Addendum No. 03

September 11, 2025

SUCF Project No. 221038-00

Renovate Pioneer Center

PREPARED FOR: STATE UNIVERSITY OF NEW YORK COLLEGE OF TECHNOLOGY AT ALFRED	RENOVATE PIONEER CENTER		
PREPARED BY: POPLI DESIGN GROUP 170 FRANKLIN ST. 8TH FLOOR BUFFALO, NY 14202 716-625-9200	JOB NO: 22.014	DATE: 09/05/2025	ADDENDA# 3
	DRAWN BY: SRF	SCALE: N.T.S.	CSK-001

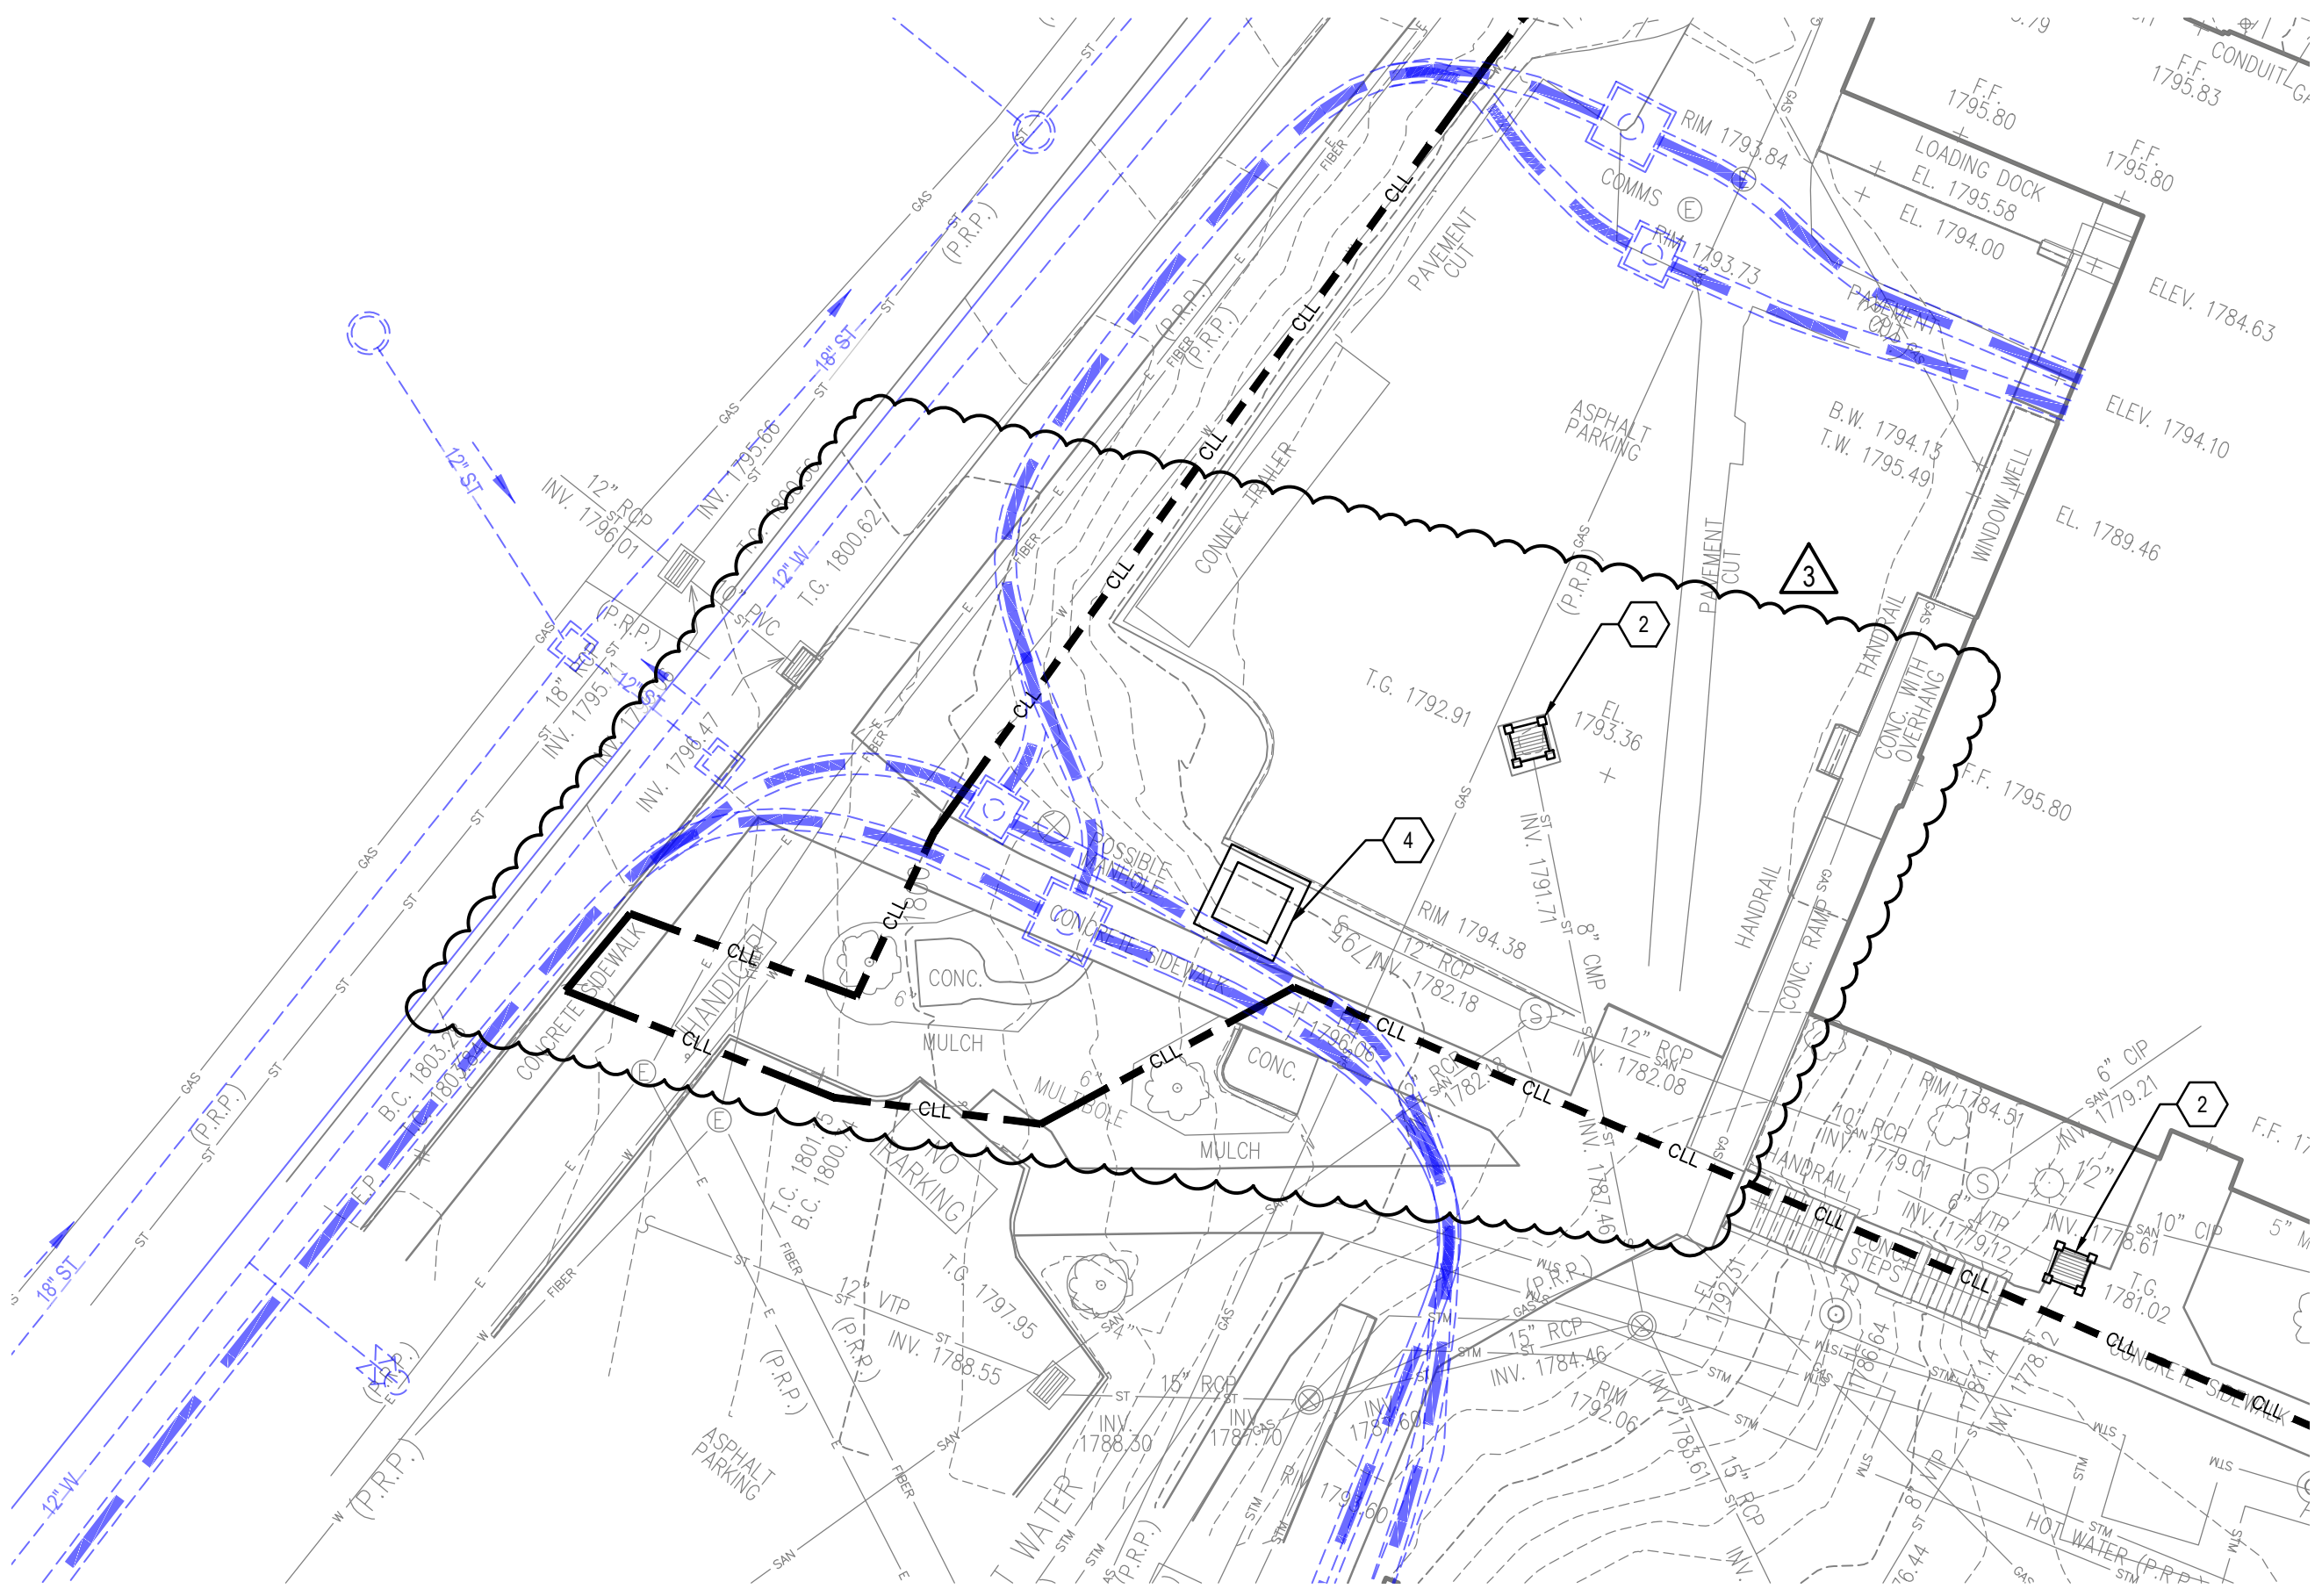
Revise: Construction Limit Line as indicated on attached Drawings CSK-001 and CSK-002.

PREPARED FOR: STATE UNIVERSITY OF NEW YORK COLLEGE OF TECHNOLOGY AT ALFRED		RENOVATE PIONEER CENTER		
PREPARED BY: POPLI DESIGN GROUP 170 FRANKLIN ST, 8TH FLOOR BUFFALO, NY 14202 716-625-9200	JOB NO: 22.014	DATE: 09/05/2025	ADDENDA#3	
	DRAWN BY: SRF	SCALE: N.T.S.	CSK-003

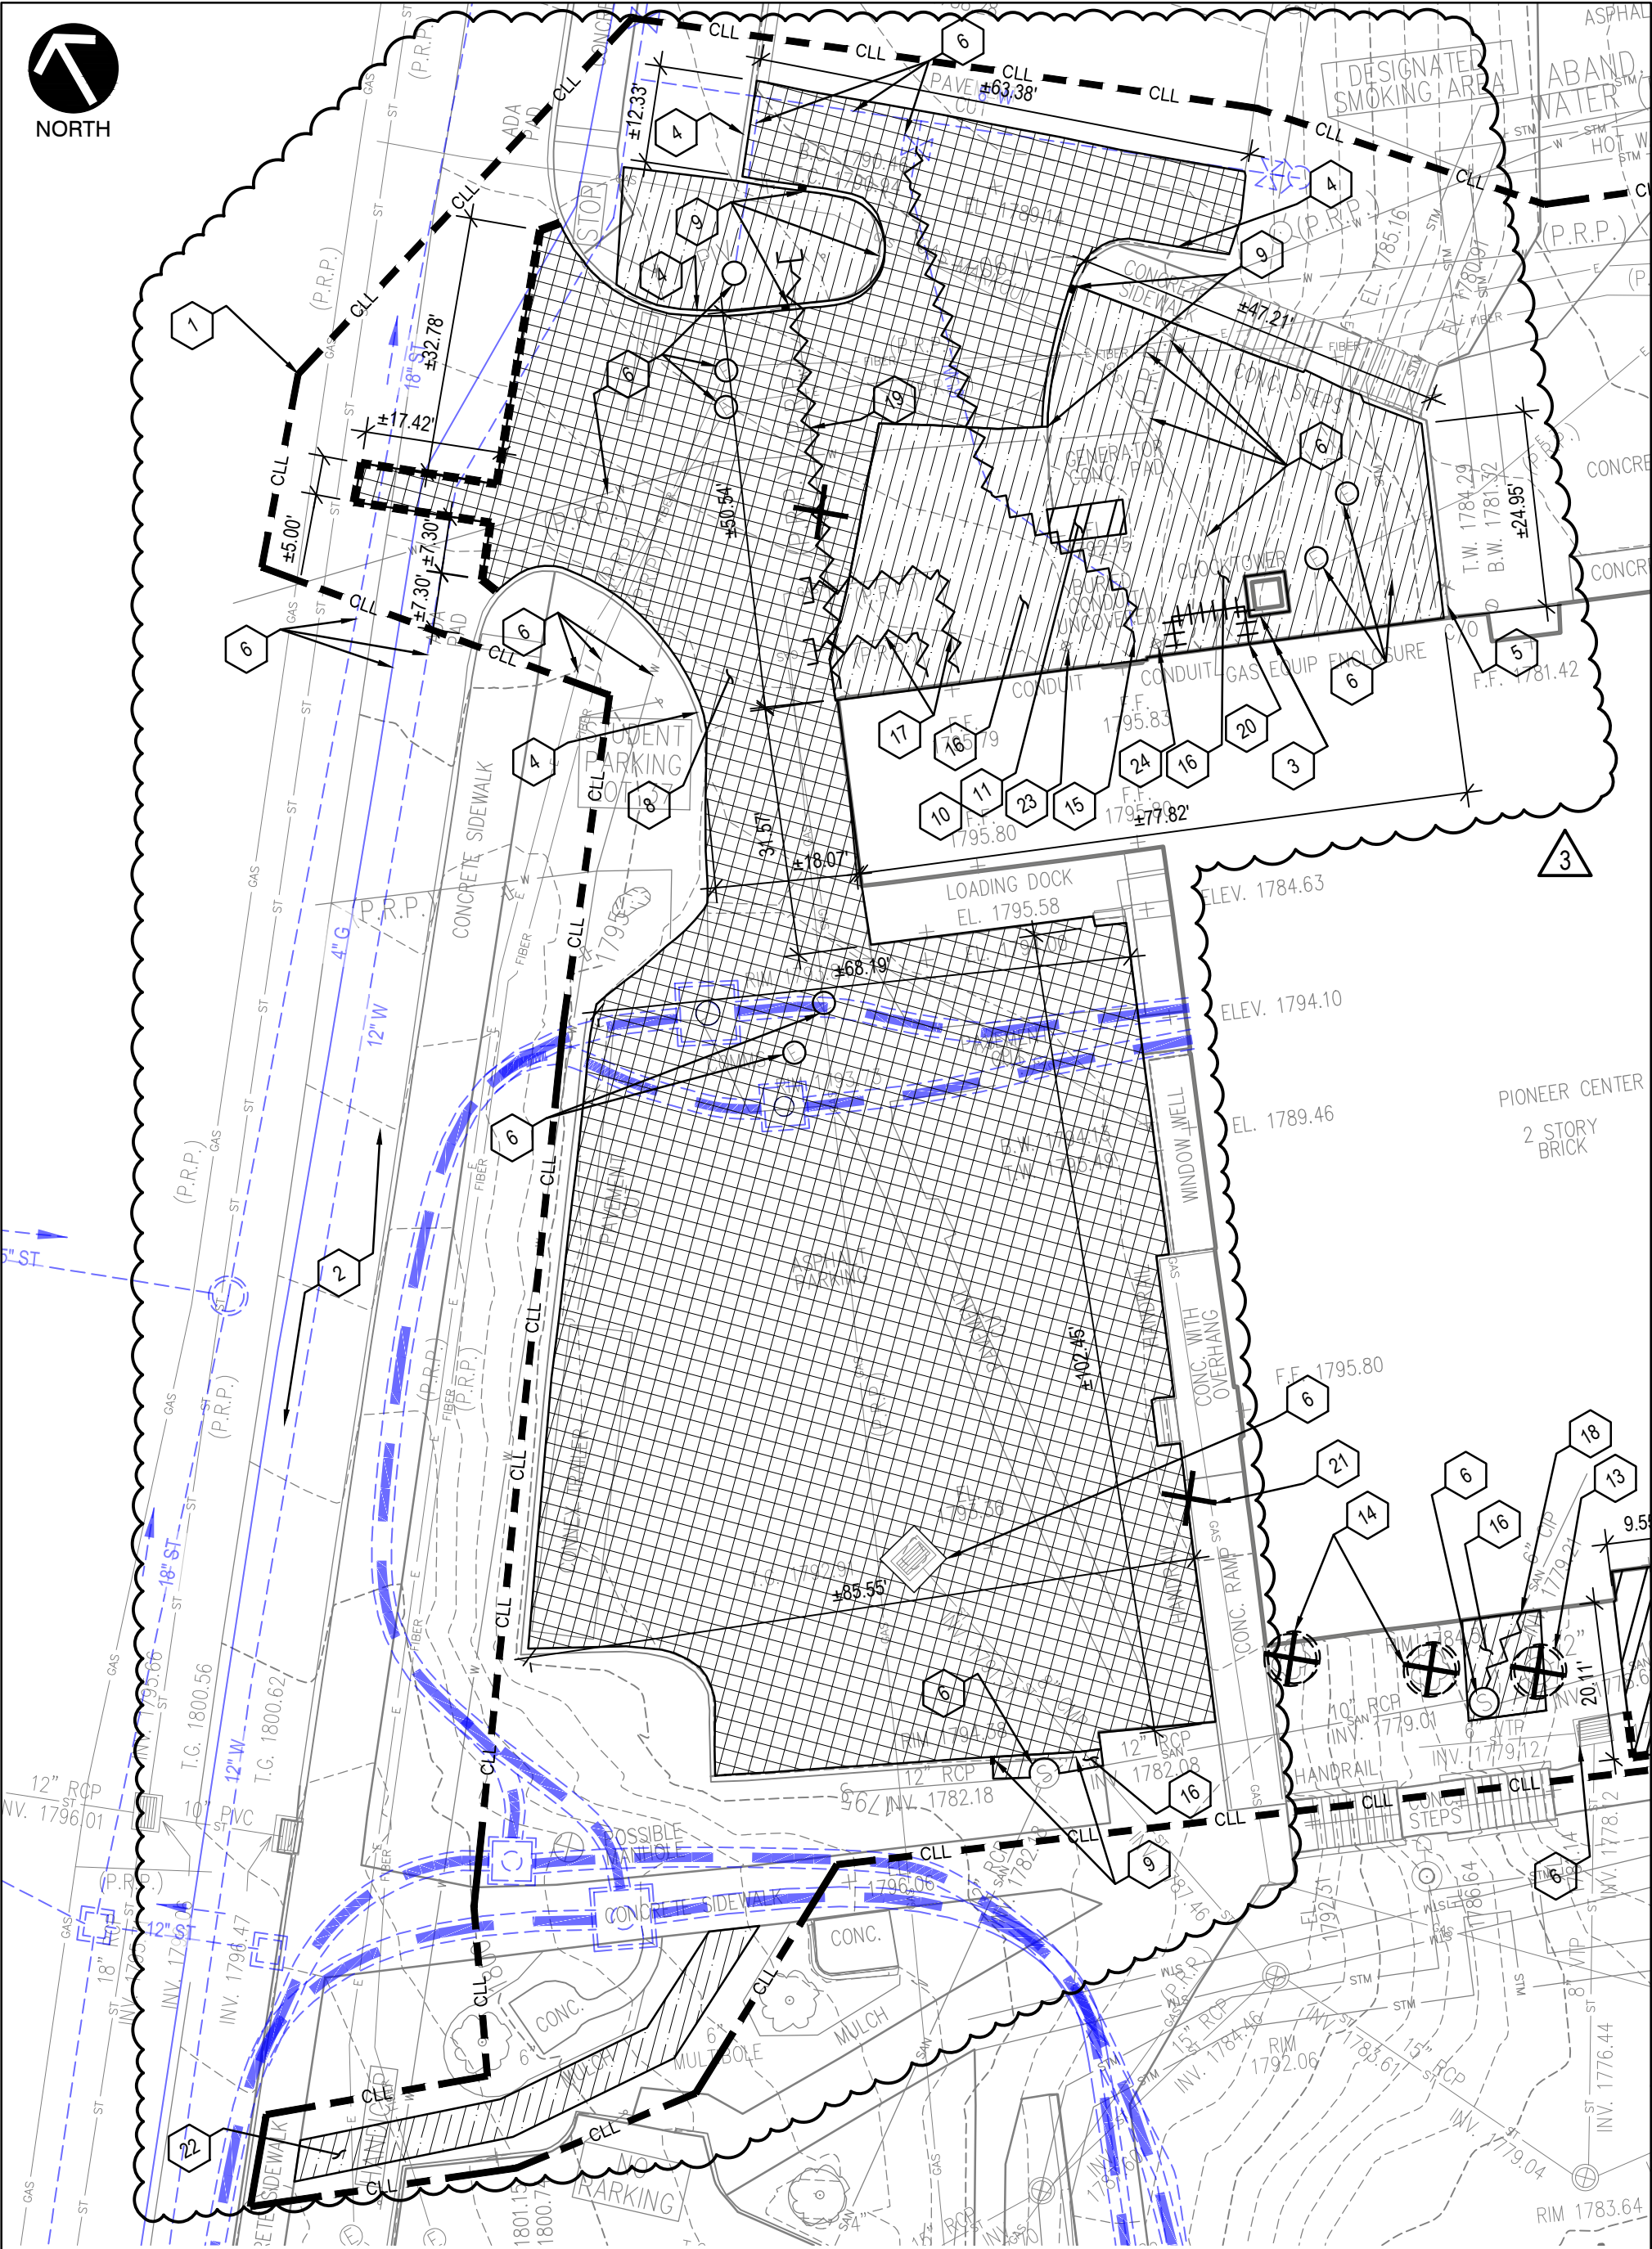
Revise: Area of removal as indicated on attached drawings CSK-003 and CSK-004.

PREPARED FOR: STATE UNIVERSITY OF NEW YORK COLLEGE OF TECHNOLOGY AT ALFRED		RENOVATE PIONEER CENTER		
PREPARED BY: POPLI DESIGN GROUP 170 FRANKLIN ST, 8TH FLOOR BUFFALO, NY 14202 716-625-9200	JOB NO: 22.014	DATE: 09/05/2025	ADDENDA#3	
	DRAWN BY: SRF	SCALE: N.T.S.	CSK-005

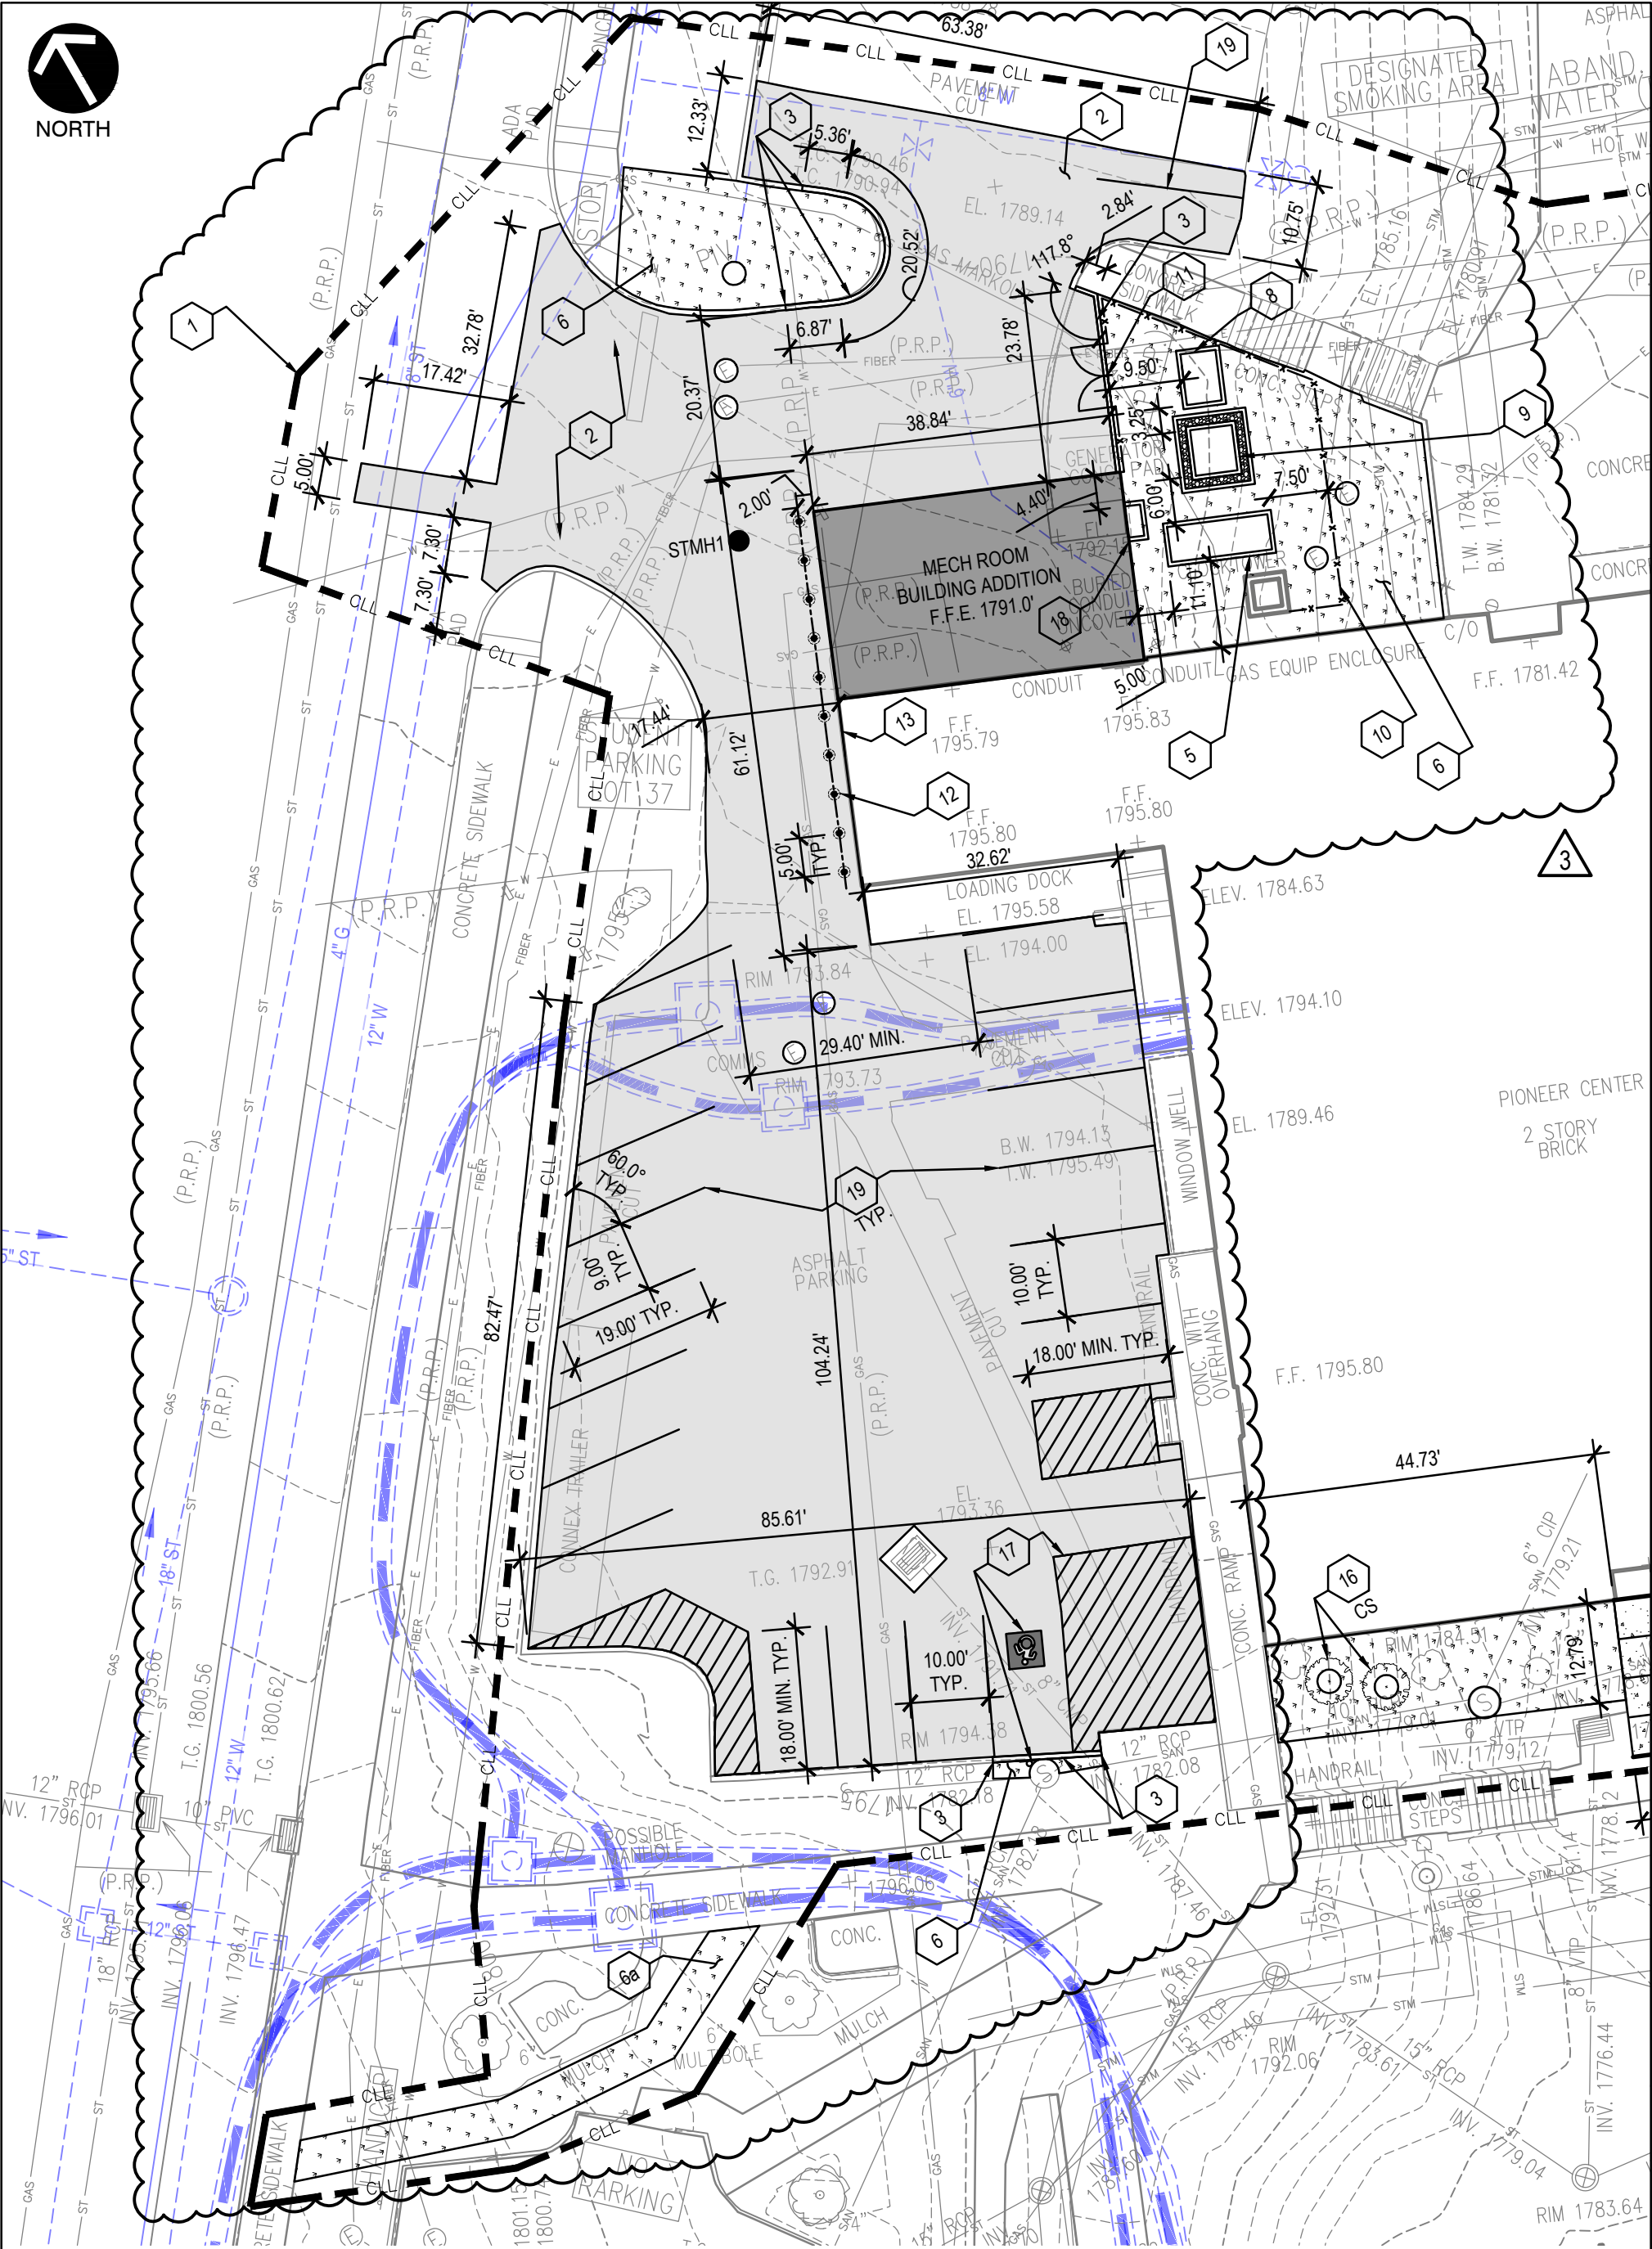
Revise: Site layout as indicated on attached drawings CSK-005 and CSK-006.
